**Subject: MHI's Response to US-APWR DCD RAI No. 550-4359 Revision 2**

**US-APWR Design Certification**

**RAI NO.:** NO. 550-4359 REVISION 2  
**SRP SECTION:** 14.03.11- CONTAINMENT SYSTEMS AND SEVERE ACCIDENTS  
**APPLICATION SECTION:** 14.3.4.11  
**DATE OF RAI ISSUE:** 3/16/2010

**QUESTION NO.:** 14.03.11-43

Figure 2.7.3.3-1 Component Cooling Water System (Sheet 1 of 2)

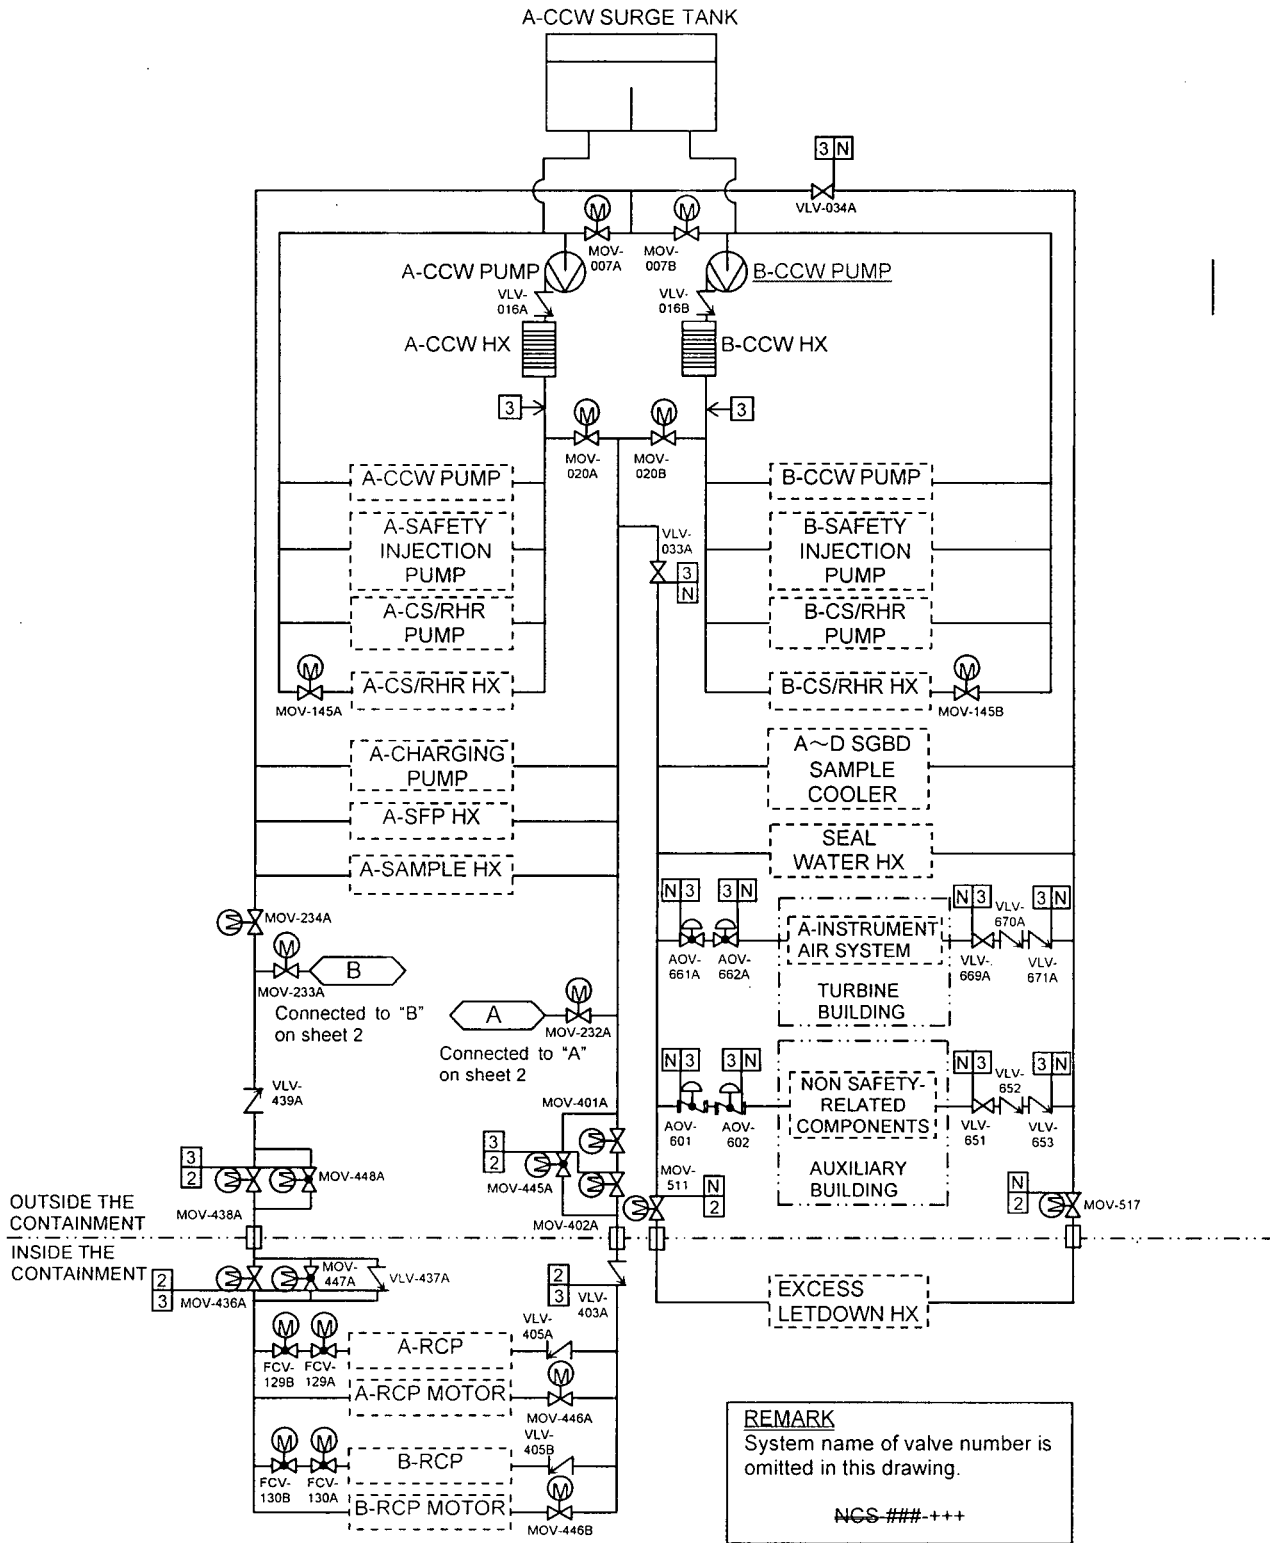
The staff noted that ITAAC item 11 in Tier 1 Table 2.7.3.3-5 is not clearly defined.

Remote operated valves to which this ITAAC item applies should be clearly identified by valve ID. Clarify this ITAAC by providing a specific reference to a valve ID in ITAAC table 2.7.3.3-4

MHI has revised Table 2.7.3.3-4 to provide a specific reference to a valve ID. In this review, MHI found the label for B-CCW pump missing in Figure 2.7.3.3-1 (Sheet 1 of 2). MHI has also revised

this typographical error on the P&ID.

See attachment 1 for the proposed markup of Table 2.7.3.3-4 and Figure 2.7.3.3-1 (Sheet 1 of 2) and attachment 2 for the markup of Table 2.7.2-2.
